JEPPESEN[®]
Airport Moving Map Alert

Subject: Kenai, Alaska
Kenai Mun (PAEN)
Cycle 2605

Temporary RWY 3/21 missing.

JEPPESEN
5 JUN 26 10-9-0

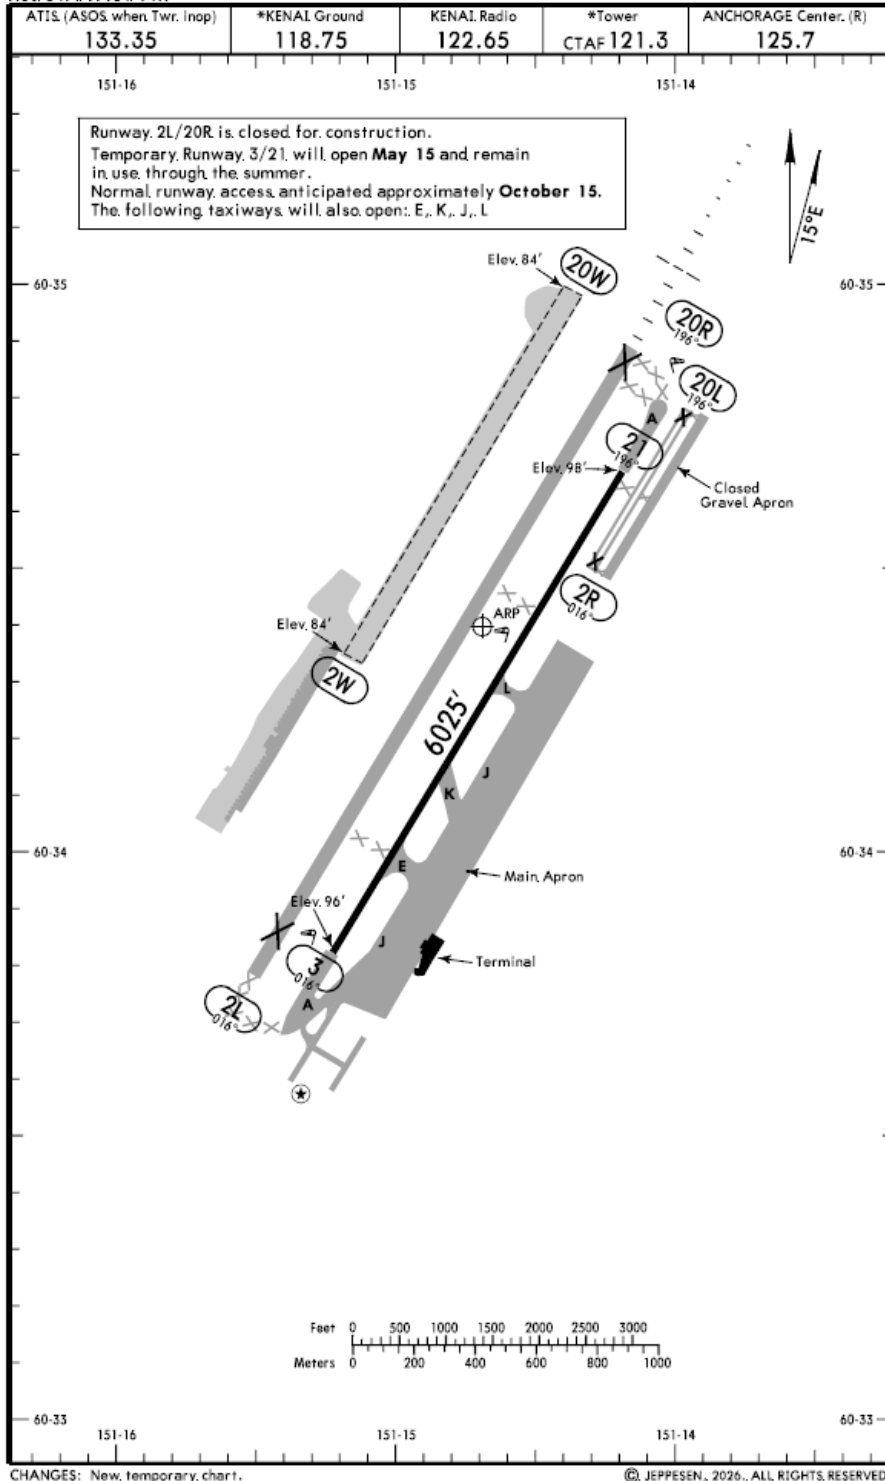
Due to construction on RWY 2L/20R, a temporary RWY 3/21 has been established on TWY A. This change is not reflected in cycle 2605 data.

Revised data will appear in Jeppesen Airport Moving Map and A816 formatted data for cycle 2606, effective 11 June 2026. Until then this Alert will be posted on the Jeppesen Web site: [Notices and Alerts](#). Please refer to the local NOTAMs and attached Kenai, Alaska (PAEN) 10-9-0 temp Chart, dated 5 JUN 26 for valid information.
